Service Bulletin No. 428

<i>MODEL</i>	D Series	<i>TYPE</i>	Field Change Program	<i>SECTION/GROUP</i>	7-Electrical	<i>DATE</i>	Oct. 30, 2015
<i>SUBJECT</i>	CONDENSER AND EVAPORATOR POWER CABLE FUSE INSTALLATION						
<i>CONDITIONS</i>

Ref. MCI NHTSA Recall No.:15V-580

Figure 2. 24 V power stud cable, p/n 07-09-1699, and fuse assembly.

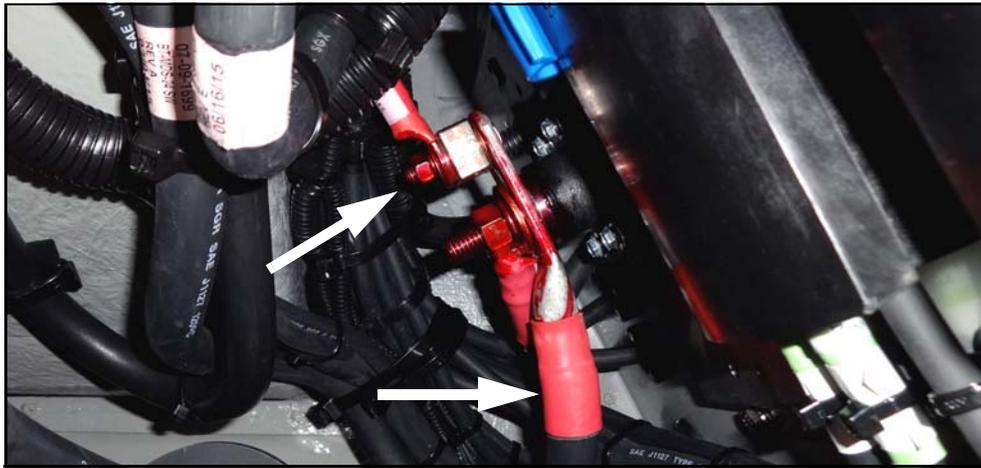
Perform a visual inspection of the 24 V power stud cable shown in Figure 2. If there is NO sign of damage due to heat or melting, proceed to Step 10.

If there are visible signs of damage due to heat or melting, contact the MCI Fleet Support Technical Center at 1-800-241-2947 for further information. Do NOT proceed to Step 10.

Disconnect the condenser / evaporator power cable, p/n 07-12-5078, from the power stud. Apply electrical tape on the terminal and remove the fuse. Orient and re-install the batteries. Re-connect the battery leads to the 24V / 12V / GND battery posts (refer to Steps 20 to 23).

Figure 3. 24 V power stud cable and routing.

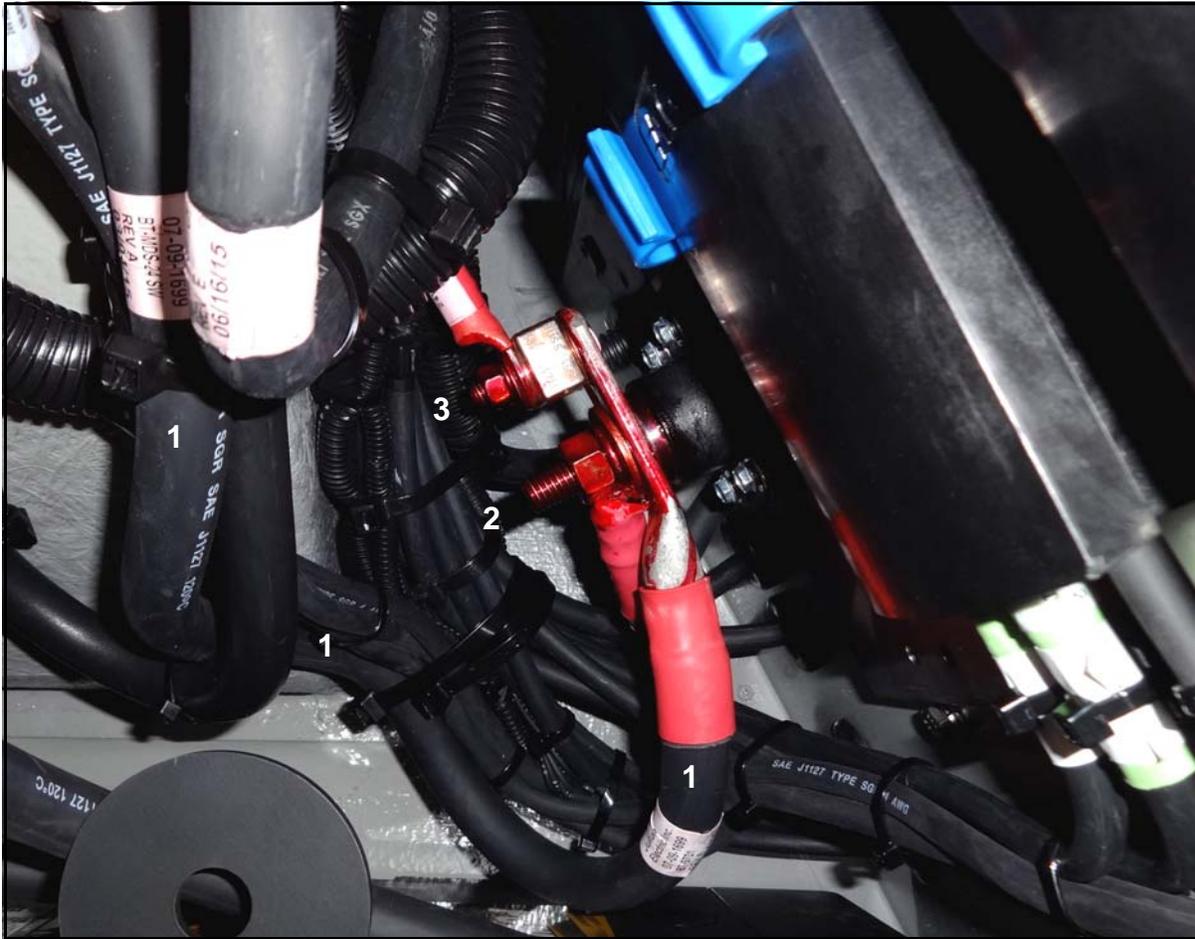
10. Locate the upper stud (0.3125 inch ID) on the 24 V power stud cable shown in Figure 3. Remove and **discard** the nut, washers and the 150 Amp fuse. Remove the cable from the fuse holder.
11. Locate the lower stud (0.500 inch ID) on the 24 V power stud cable shown in Figure 3. Remove and **retain** the nut, lock washer and flat washer. Disconnect the harness (Item 8 / Figure 4) from the stud.
12. Follow the routing of the disconnected 24 V power stud cable to the main disconnect switch (MDS). Remove and retain the nut from the stud on the main disconnect switch. Remove and discard the harness bundle tyrap and the 24 V power stud cable.

13. Orient the new 24 V power stud cable, p/n 07-09-1699, from the fuse holder to the main battery disconnect switch stud referred to in Step 12.
14. Using the nut removed in Step 12, secure the 24 V power stud cable to the stud on the main disconnect switch. Torque to 20-25 ft-lbs.

Figure 4. Upper stud install orientation.

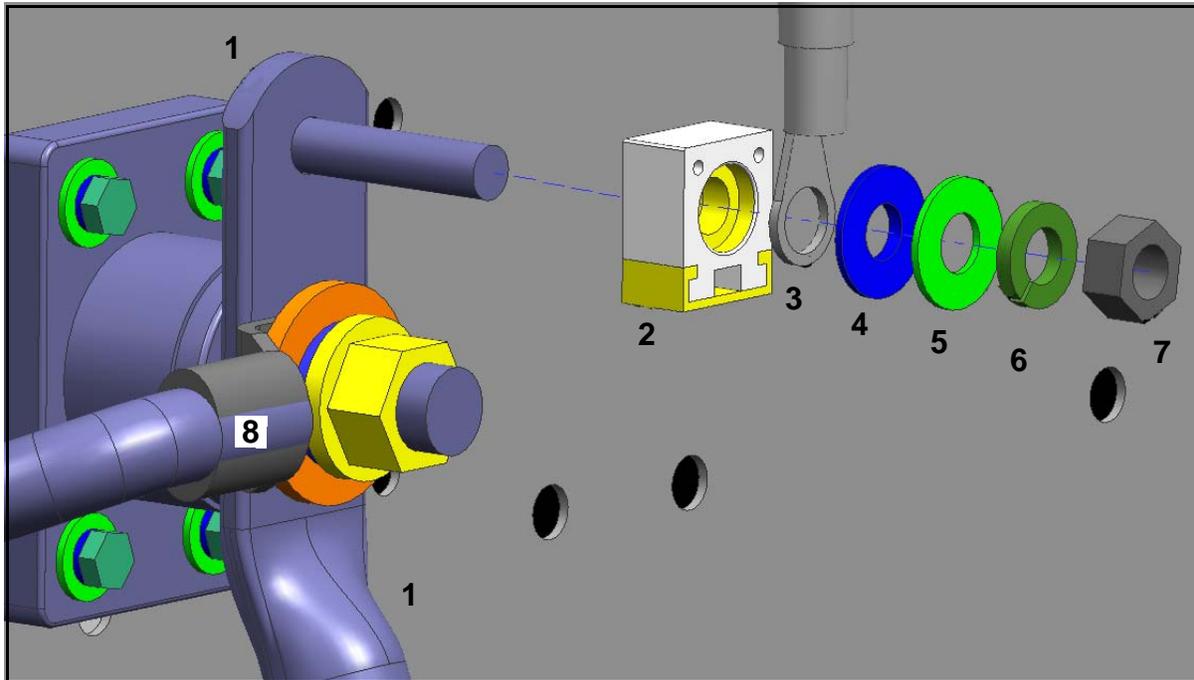
The cause of the defect is the incorrect placement of the nylon shoulder washer.

To ensure proper assembly installation, orient the nylon shoulder washer (Item 4 / Figure 4) with the shoulder facing the ring of the condenser and evaporator power cable.

15. Locate the upper stud (0.3125 inch ID) on the 24 V power stud cable, orient the new parts in the exact order shown in Figure 4. Torque the nut to 96-106 in-lbs.

16. Locate the lower stud (0.500 inch ID) on the 24 V power stud cable, using the existing nut, lock washer and flat washer install the harness (Item 8 / Figure 4). Torque the nut to 290-310 in-lbs.
